**ADDENDUM #1**

ISSUED BY EDiS COMPANY  
110 S. POPLAR STREET, WILMINGTON, DE 19801

1.3.3 Bids should be in a sealed envelope clearly marked **APPOQUINIMINK SCHOOL DISTRICT FAIRVIEW CAMPUS NEW MIDDLE SCHOOL & HIGH SCHOOL, BID PACKAGE ‘A’, CONTRACT NUMBER A-1 PRE-BULK GRADING.**

**BULK GRADING PLANS**  
**ADDENDUM #1 EXHIBIT**  
FOR  
**FAIRVIEW CAMPUS**

**C-703**

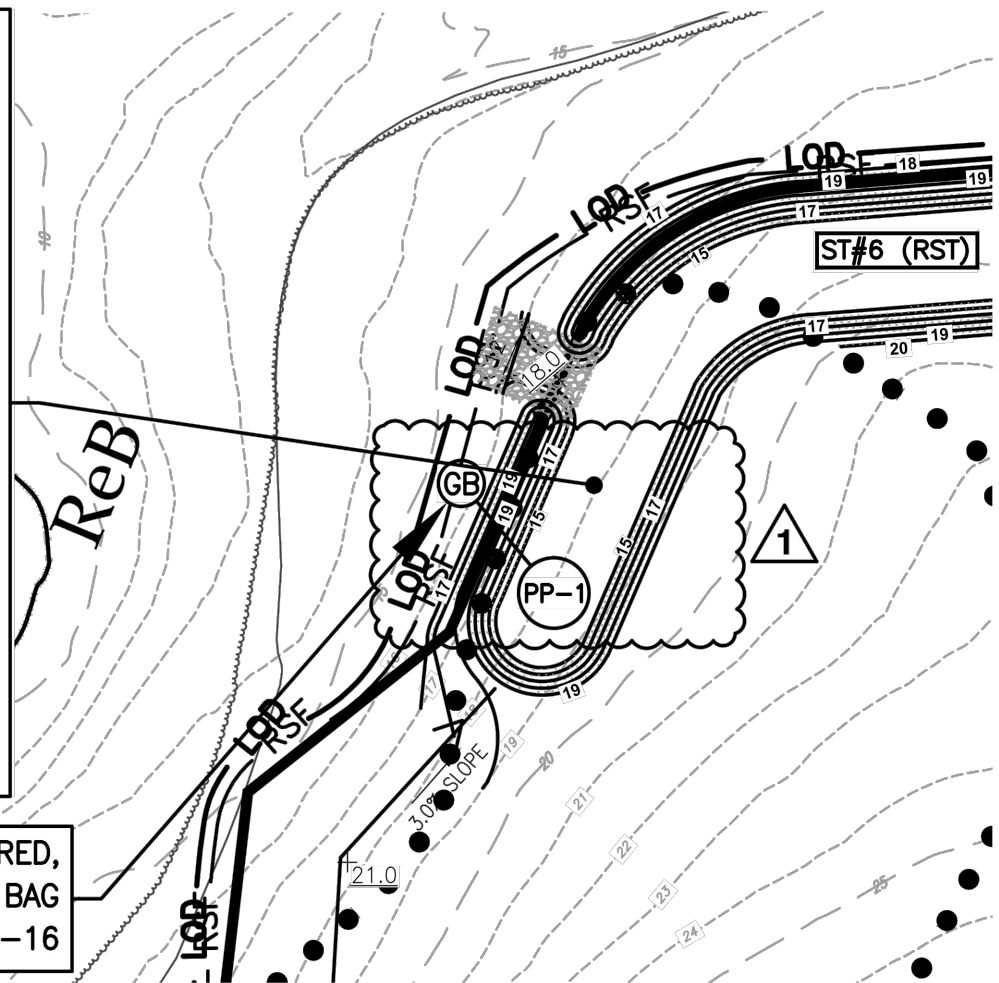
- Civil Sketch C-701 : Revised Parcel Data Schedule
- Civil Sketch C-702 : Revised Sediment and Stormwater Construction Notes #8 & 10
- Civil Sketch C-703 : Revised Sediment Trap ST#1 adding in pumping pit
- Civil Sketch C-704 : Revised Sediment Trap ST#6 adding in pumping pit
- Civil Sketch C-705 : Revised Sediment Trap ST#2 adding in pumping pit
- Civil Sketch C-706 : Revised Sediment Trap ST#8 adding in stabilization matting
- Civil Sketch C-707 : Revised layout of haul road at ST#7
- Civil Sketch C-708 : Revised Sediment Trap ST#3 adding in pumping pit
- Civil Sketch C-709 : Revised Sediment Trap ST#4 adding in pumping pit
- Civil Sketch C-710 : Revised Sediment Trap ST#5 adding in pumping pit
- Civil Sketch C-711 : Pumping Pit – Type 1 Detail

***C-710***

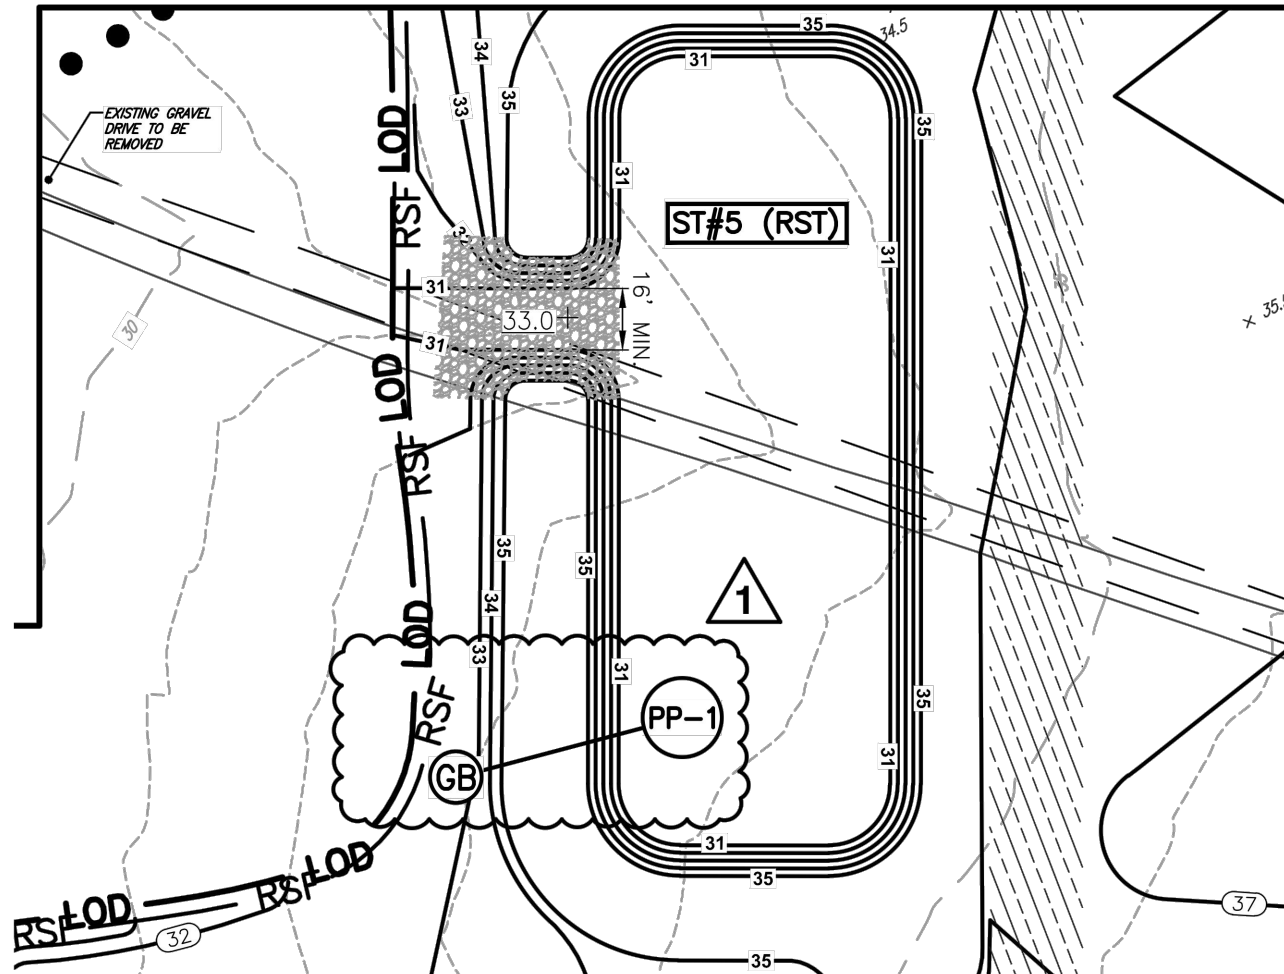
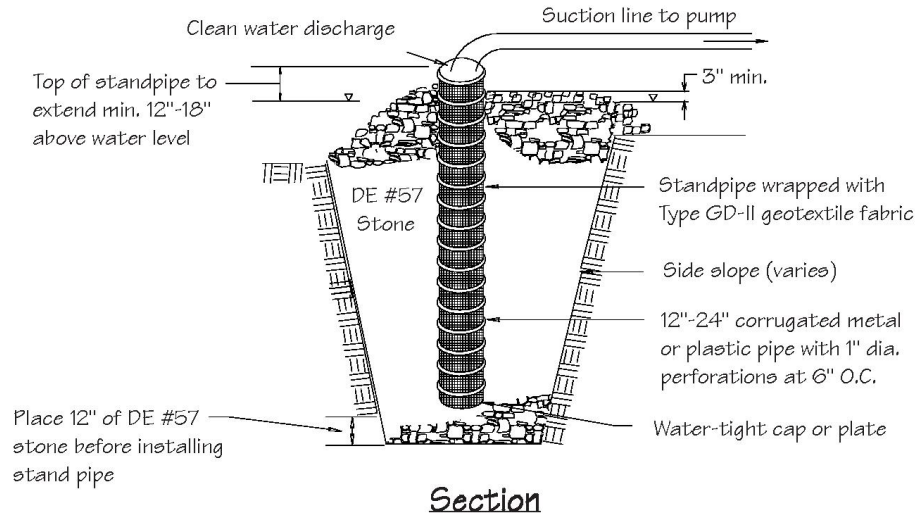
- k) Drawing CE-13 : Insert attached civil sketches; C-708, C-709, and C-710 into the project document.
- l) Drawing CE-14 : Insert attached civil sketches; C-711 and C-712 into the project document.

| DESIGNED BY: JAV | COMMISSION NO: C2226-8 | DRAWING NAME: Bulk Grade Set.dwg | SHEET NO. CE-02 of 19  |

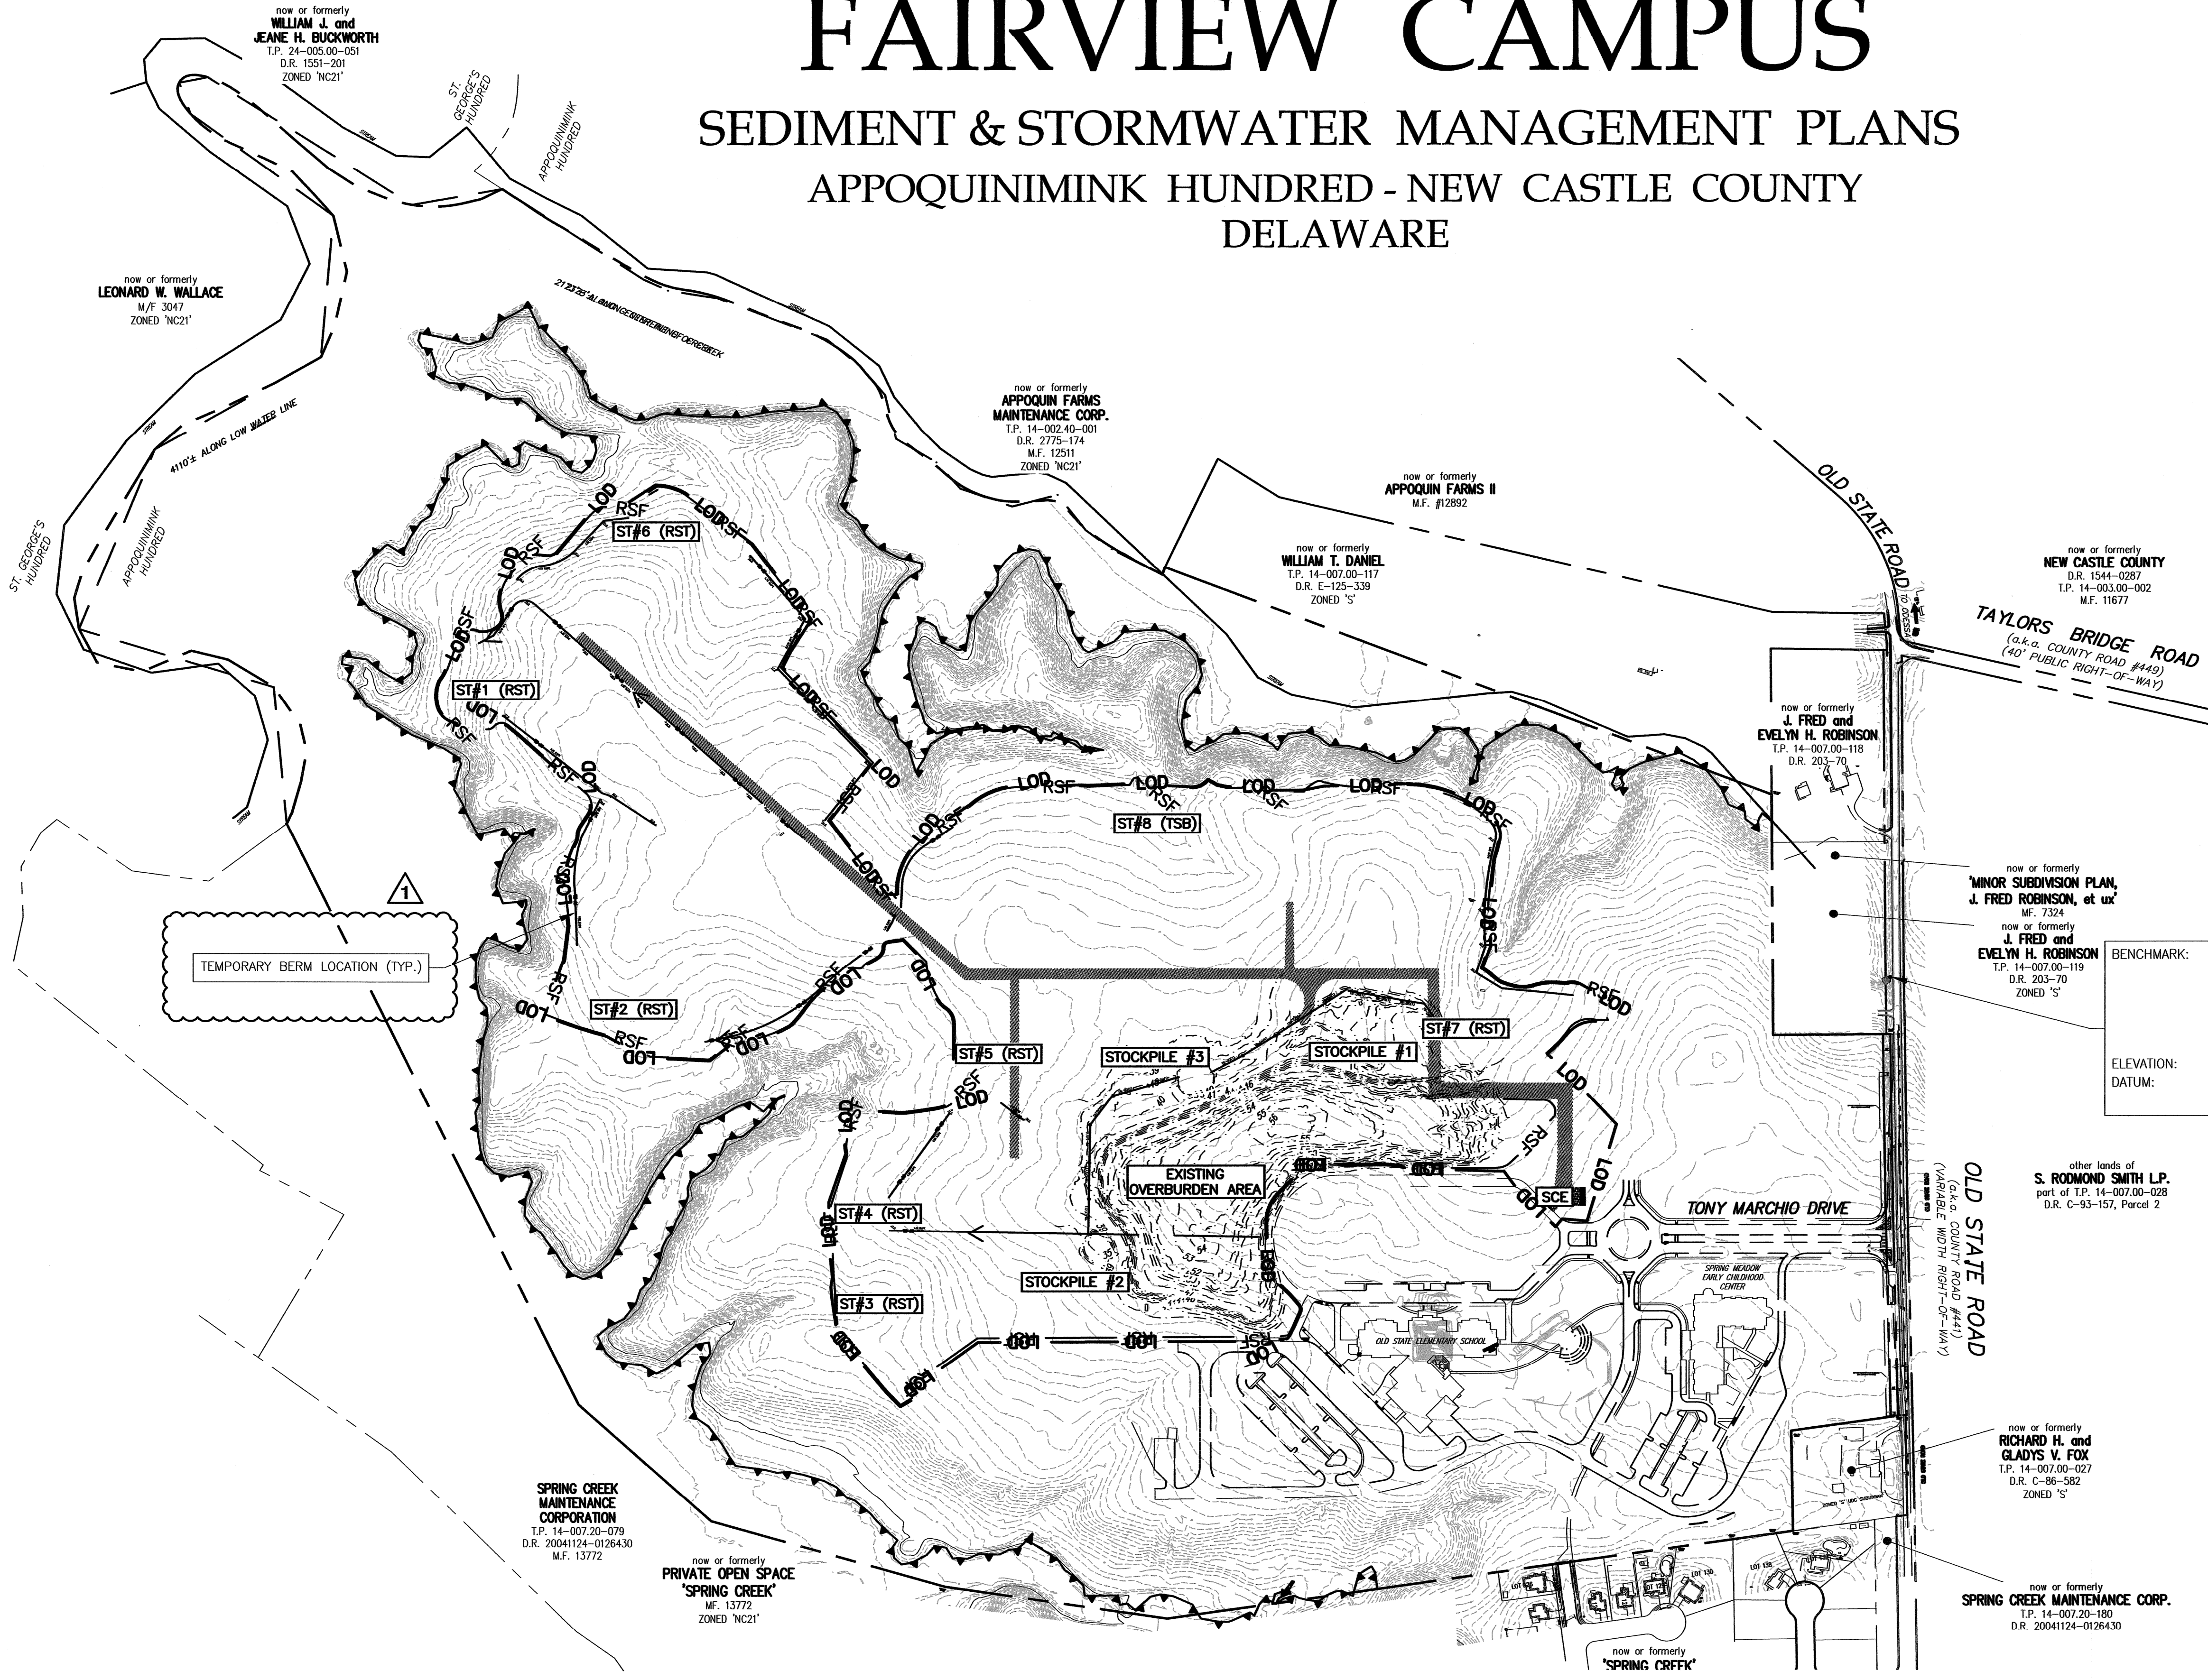
- a) Drawing CE-01 : Insert attached civil sketches; C-701 and C-702 into the project document.
- b) Insert drawing CE-01A into project documents.
- c) Delete existing drawing CE-02 and insert attached drawing CE-02 annotated Addendum #1 dated 5/23/17 into the project documents.
- d) Drawing CE-03 : Insert attached civil sketches; C-703 and C-704 into the project document.

| PROPOSED | REVISIONS | 1. ADDENDUM #1 REV. PER DREC COMMENTS |

| DRAWN BY:      | JRB                          | SCALE:    | AS NOTED |
|----------------|------------------------------|-----------|----------|
| SHEET NO.      | CE-18                        |           |          |

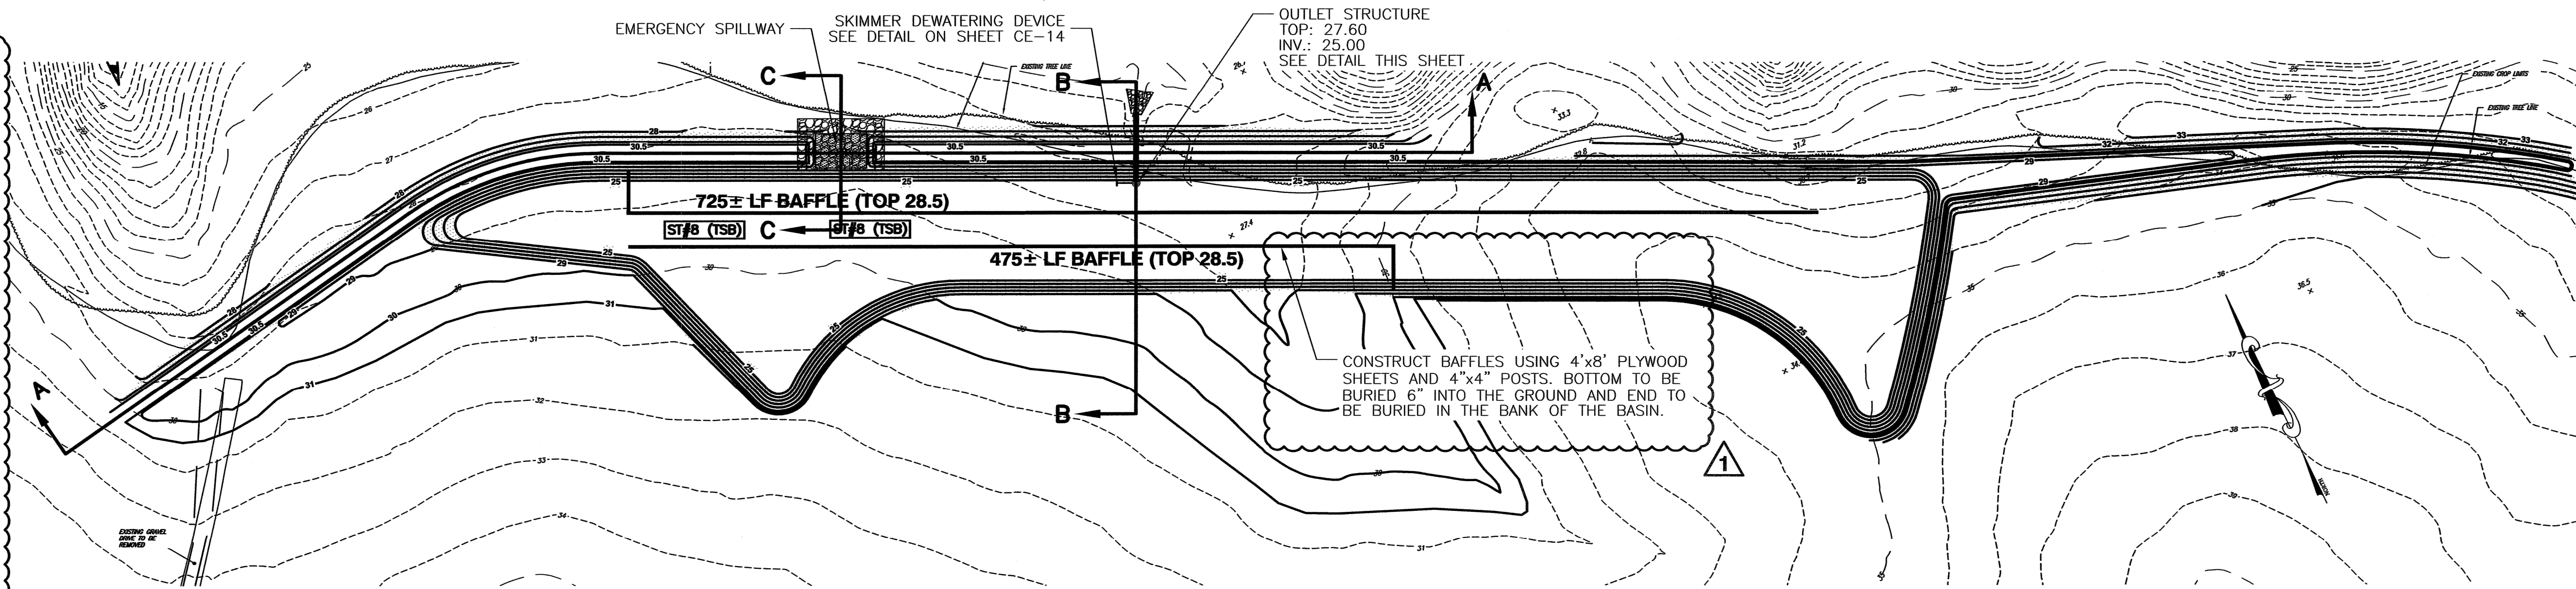
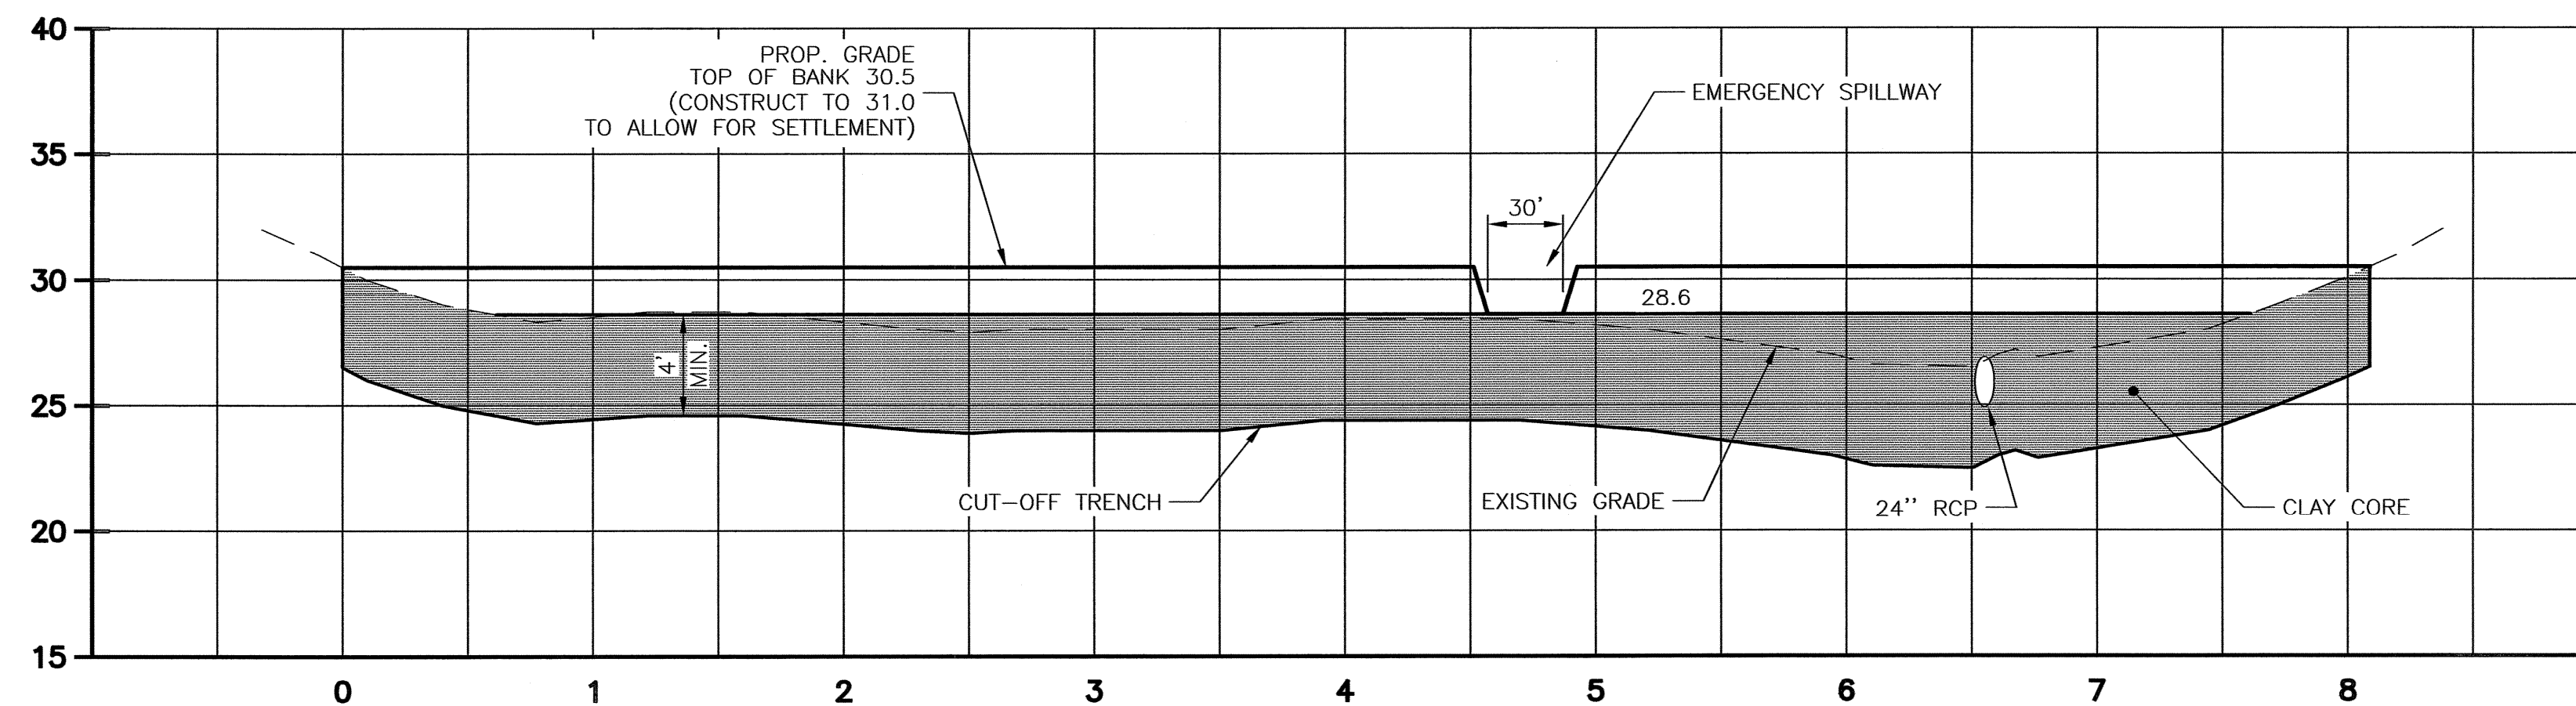
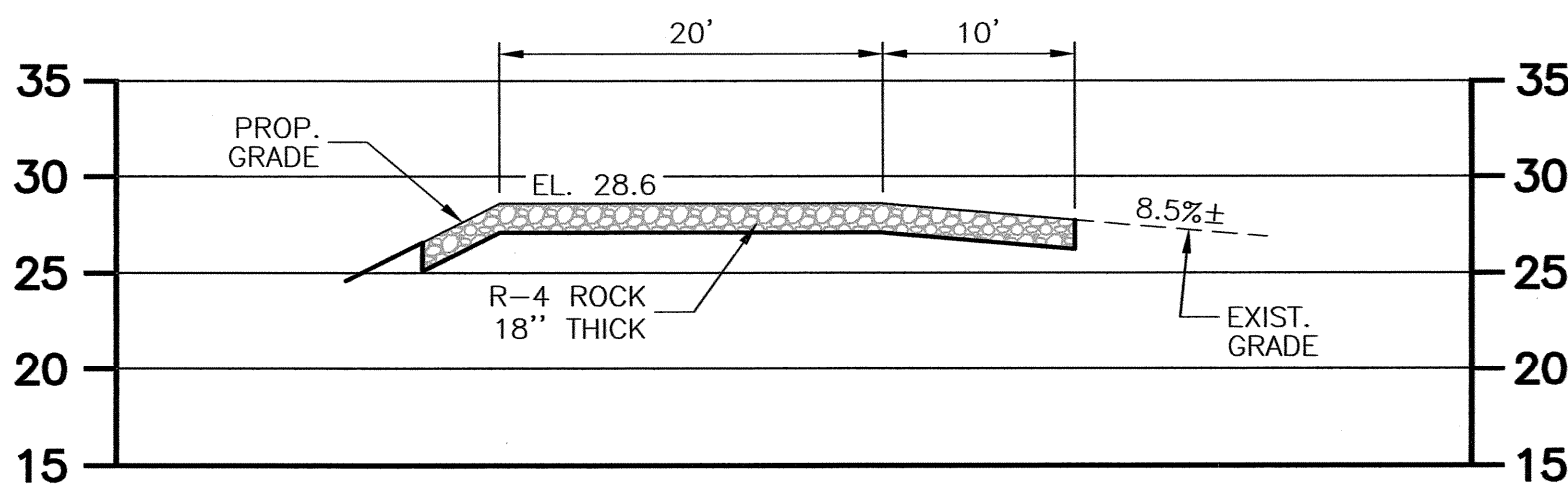
- o Page 9 – Add bullet #27, "*Provide As-Built Survey immediately following the completion of Sediment Basin #8 as stipulated in the Sequence of Construction provided on Sheet CE-18. Contractors are to provide a certified as-built drawing in PDF along with an AutoCad 3D drawing file.*"

- m) Drawing CE-17 : Insert attached civil sketches; C-713 and C-714 into the project document.
- n) Delete existing drawing CE-18 and insert attached drawing CE-18 annotated Addendum #1 dated 5/23/17 into the project documents.
